# Access Compliance Report

## Public Rights-of-Way

| Intersection ID: 19543                  | Main Street: SCOFIELD_RD | Cross Street: TOPPING_PL                | Location: S            |
| ADA ID: EE68D406176D                    | Ramp Type: BlendTrans2   | Initial Pass/Fail: Pass                 | Overall Compliance: No |

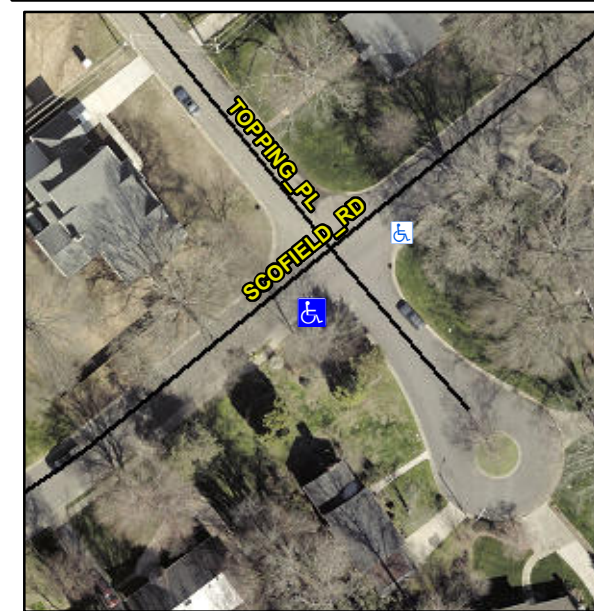
**Not Found, R304.5.3, R304.2.3**

| Compliance | Description           | Data   | Compliance | Description                 | Data   |
|------------|-----------------------|--------|------------|-----------------------------|--------|
| Yes        | Ramp Width (in)       | 48.0   | No         | BlendTrans XSlope (%)       | 2.3    |
| N/A        | Flare Slope LT (%)    | N/A    | No         | Flare Slope RT (%)          | N/A    |
|            |                       |        | No         | Curb Slope (%)              | 8.6    |

**Remove & Replace Curb Ramp With Two New Directional Ramps or Equivalent.**
